TO:MR. DAVID CROXTON
HW-106

FROM:ROBERT FARRELL

SUBJECT:BURLINGTON, PIER 91, OCTOBER, 1993 RFI REVIEW

Summary--The investigation into the shallower aquifer seems to be adequately done so that a corrective action program can be developed. The RFI for the deeper ground water does not appear to have been adequately completed and numerous questions still remain to be answered.

FIGURE 7

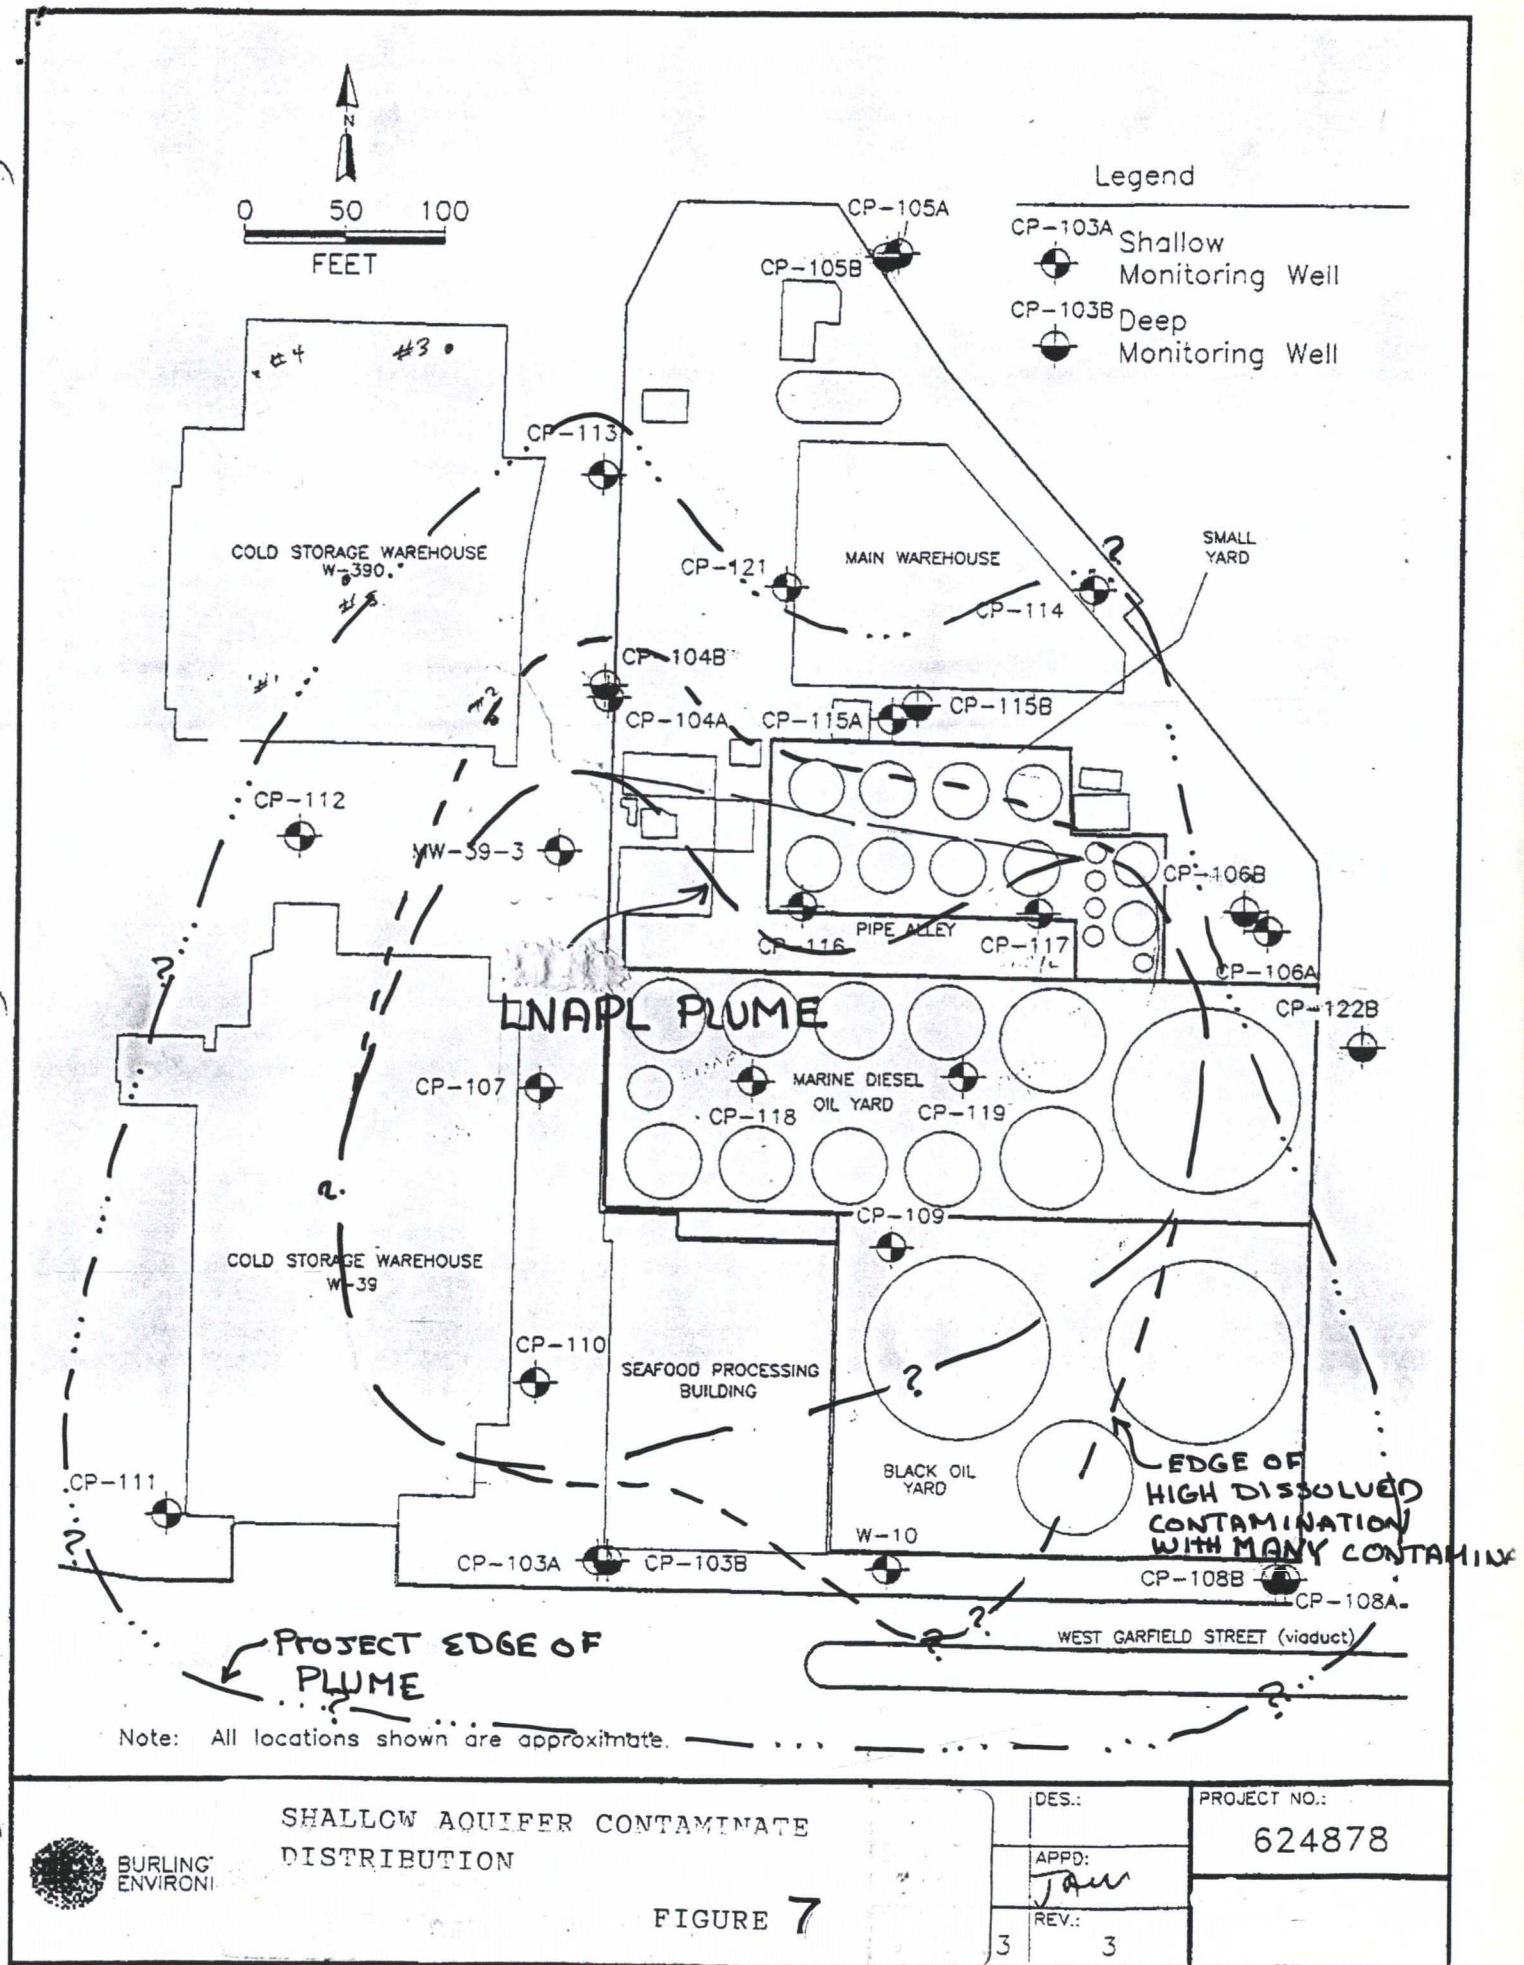
LNAPL has been detected on the wells shown on the attached figure 7. As was indicated above this LNAPL plume corresponds closely with the wells having the highest concentration of contaminants as well as the most extensive number of contaminants in the shallow ground water. address after LNAPL? get these at same time as LNAPL!
